<p>CARNEGIE FORUM 305 WEST PINE STREET LODI, CALIFORNIA</p>	<p>SPECIAL AGENDA LODI SITE PLAN & ARCHITECTURAL REVIEW COMMITTEE</p>	<p><u>SPECIAL MEETING</u> MONDAY, June 23, 2008 @ 5:15 PM</p>
---	--	--

To: Site Plan and Architectural Review Committee
From: Immanuel Bereket, Junior Planner, Community Development Department
Date: June 23, 2008
Subject: Request for Site Plan and Architectural Review Committee approval to renovate an existing building and to construct an addition for Speedee Oil Change & Tune Up at 305 West Lodi Avenue. (Applicant, Dave Keith; File# 08-SP-02).

SITE PLAN
1" = 10'-0"

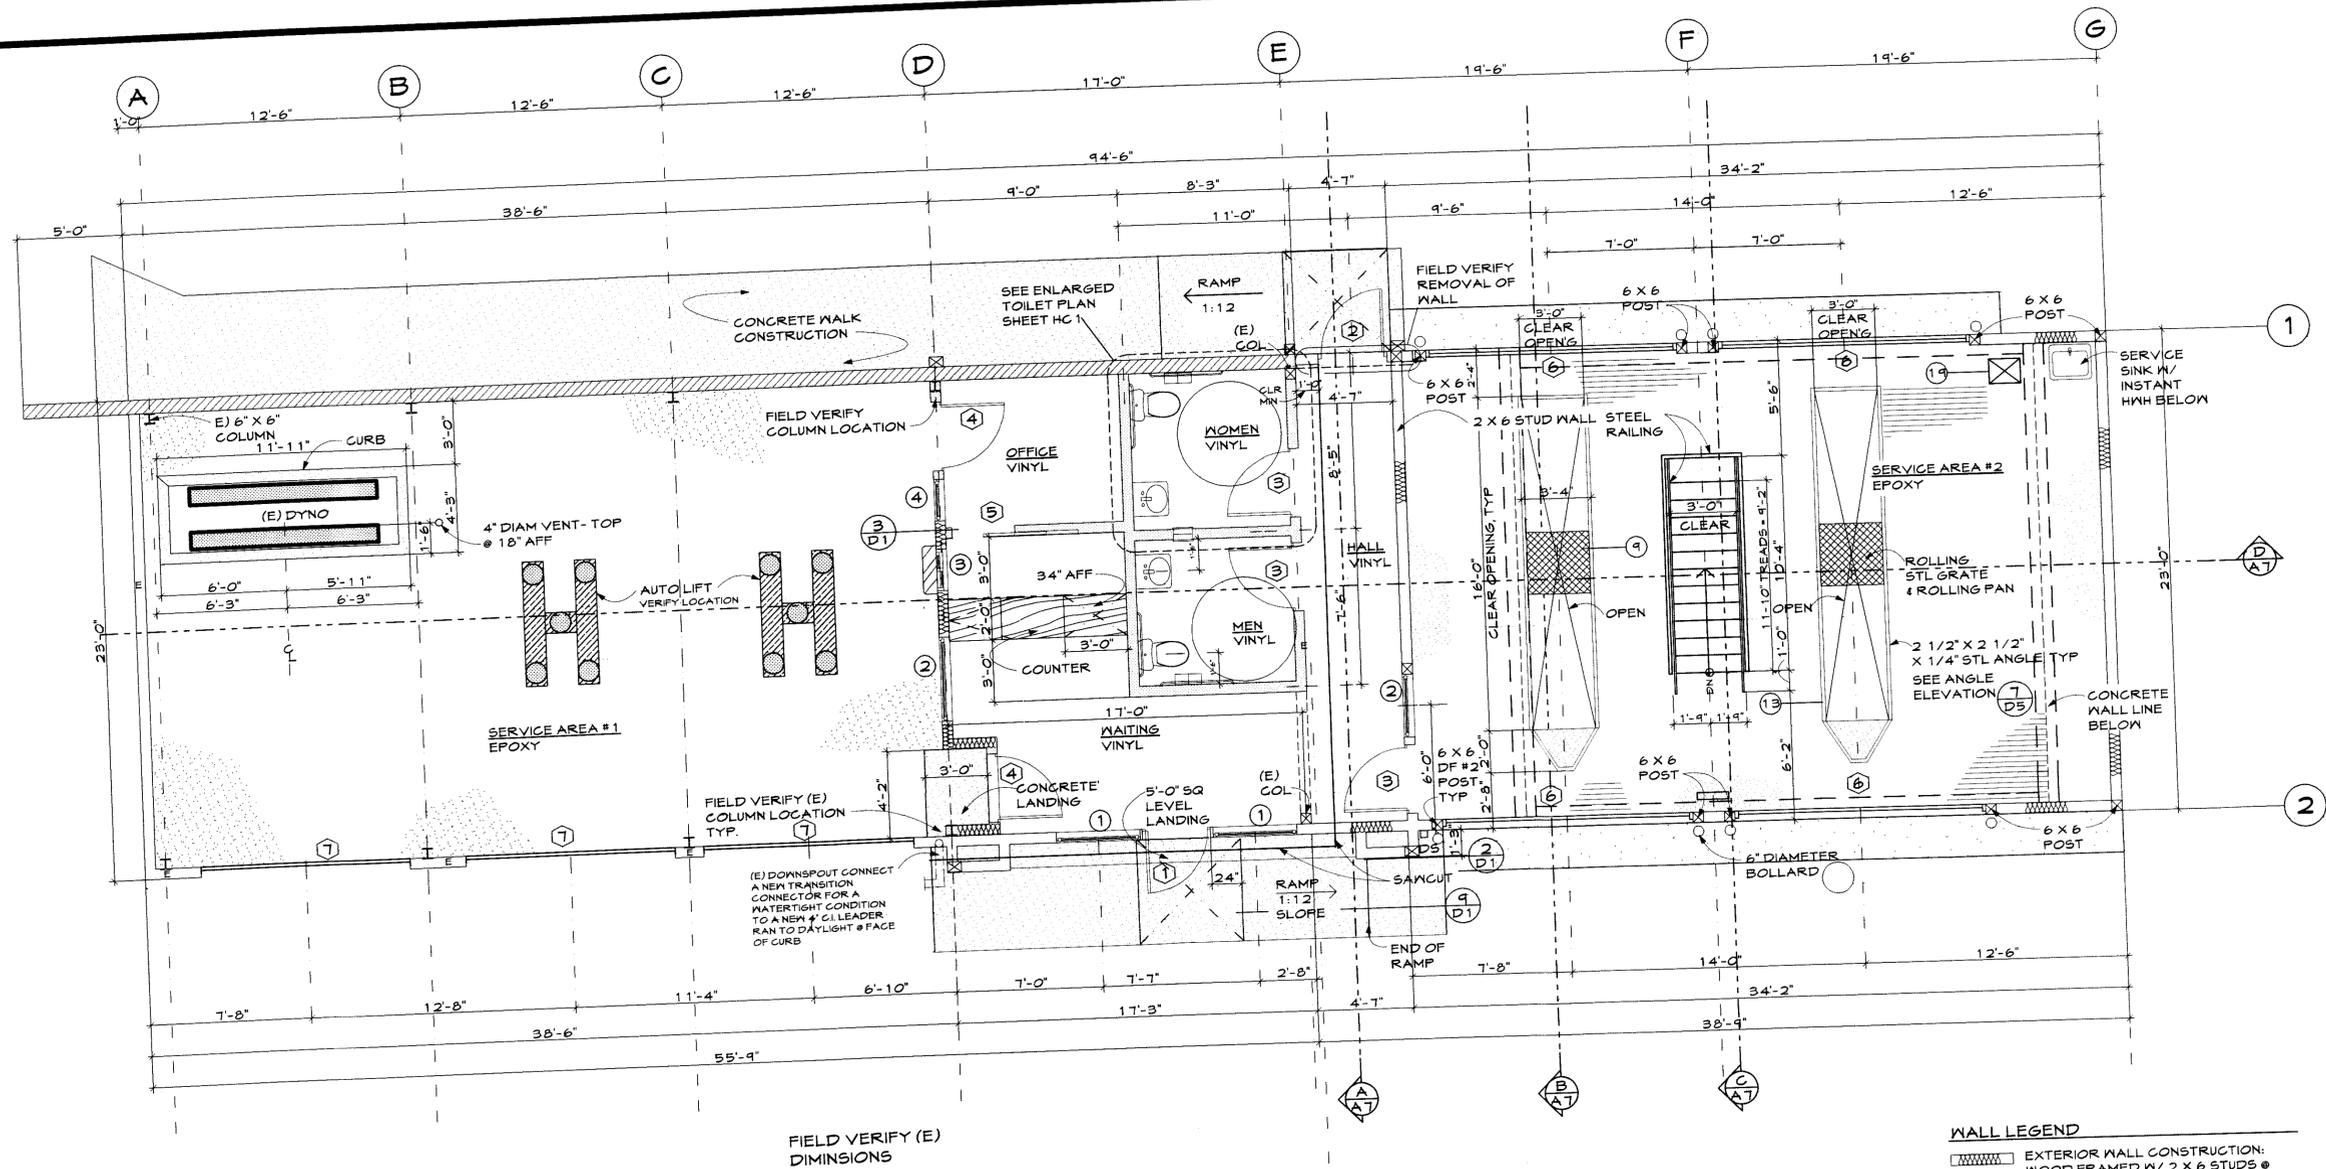
12. A parking space labeled No.1 on the site plan shall be removed and replaced with landscaping.
13. The landscaping plan shall be increased around the trash enclosure complete with creeping vines in order to prevent graffiti type vandalism in the future.

16. The applicant shall provide a dimensioned site plan showing the existing site layout, proposed site layout and all utilities. The project driveway shall conform to Standard Plan 111 and shall include "Exit Only" sign on the proposed one-way driveway.

17. The parking layout shall conform to Standard Plan 134. Dead end 90 degree parking shall be provided with adequate turning room.

19. The applicant shall start the 4-foot transition on Pleasant Avenue after the proposed driveway transition instead of the parcel boundary.

20. The applicant shall add a note to the plans for the removal of the driveway being removed on Lodi Avenue and replacement with curb, gutter and sidewalk conforming to Standard Plan 135.
